GOVERNMENT OF MADRAS.

PUBLIC WORKS DEPARTMENT.

ORDER—No. 3059 W., dated 3rd November 1897.

Name of Work Constructing an office for the
Asst. Sup^t of Police at Palghat.

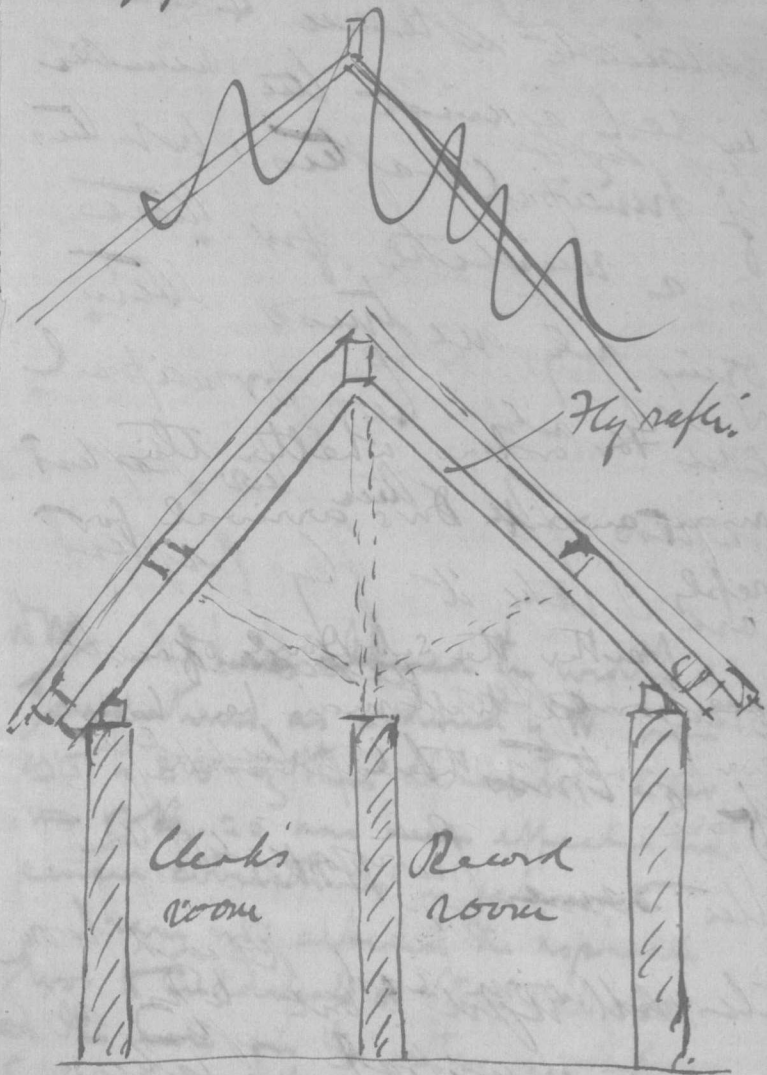
3. I don't like the
fly rafter construction
much -
wherever it is used
it is a very poor
light and
way stand.

I do not see how
 fly rafters are to be
 supported.

What supports the
 fly rafters. There are no
 post or studs as shown
 by the dotted lines.
